Work Order ID 136723

Item Name: Quick Release Heli-Utility-Basket™ Long,Light Lid, Spacepod™/Squirrel Cheek Comp

DART SERVICE INSTRUCTION

TO AMEND INSTALLATION INSTRUCTIONS D350-607-3 Rev.D,
INSTALLATION INSTRUCTIONS D350-607-4 Rev. C AND
INSTRUCTIONS FOR CONTINUED AIRWORTHINESS ICA-D350-607 REV. 6

FIGURE 1: INSTALLATION OF D4775-041 FWD STRUT

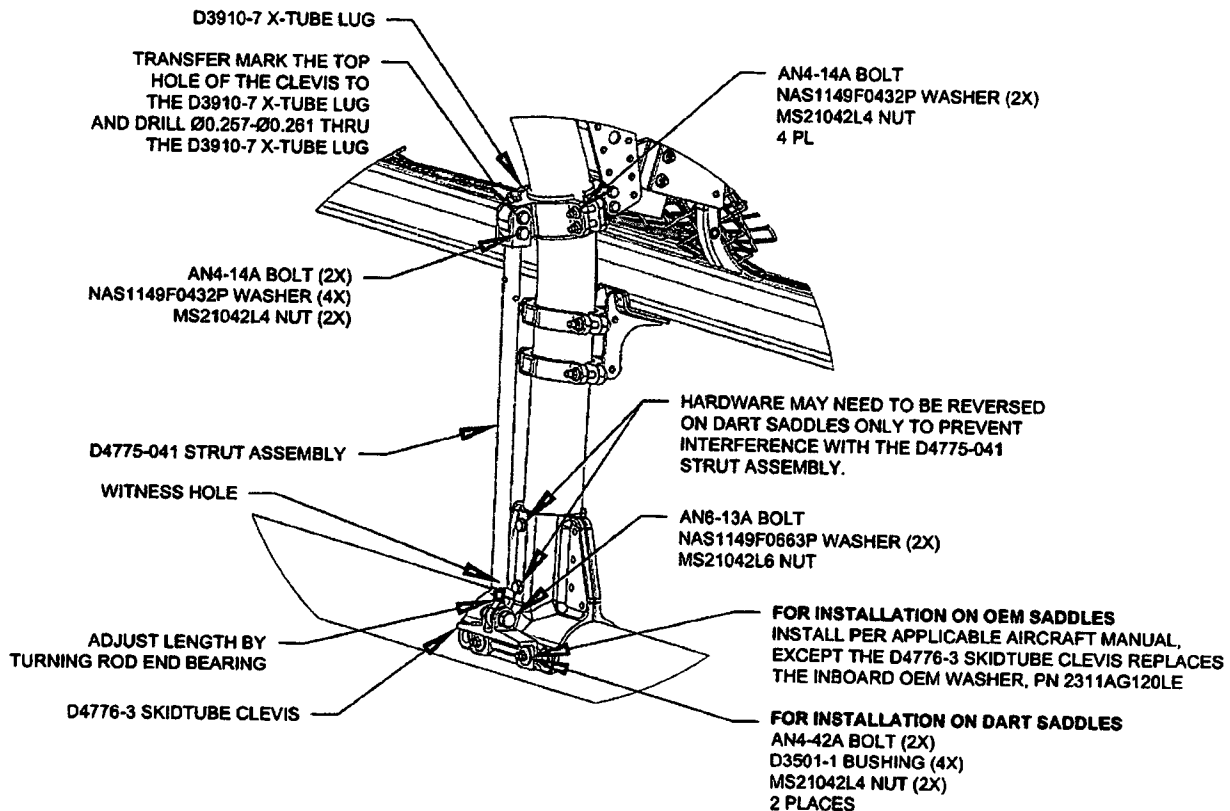
3.1 Substitute the Forward Lower D3910-5 X-Tube Lug with the D3910-7 X-Tube Lug as shown in Figure 1.

3.2 Install the forward D4775-041 Strut Assembly. Transfer mark from the upper hole on the clevis of the D4775-041 Strut Assembly to the D3910-7 X-tube Lug and drill thru the lug $\varnothing 0.257$ - $\varnothing 0.261$ as shown in Figure 1. Touch up chemical conversion coating per MIL-DTL-5541. Check the witness holes located at the bottom end of the D4775-041 Strut Assemblies to ensure that the thread from the rod end extends past the witness hole.
Torque MS21042L4/-4 nuts to 50-70 in-lbs (5.7-7.9 N-m). Torque MS21042L6/-6 nuts to 160-190 in-lbs (18.1-21.5 N-m).
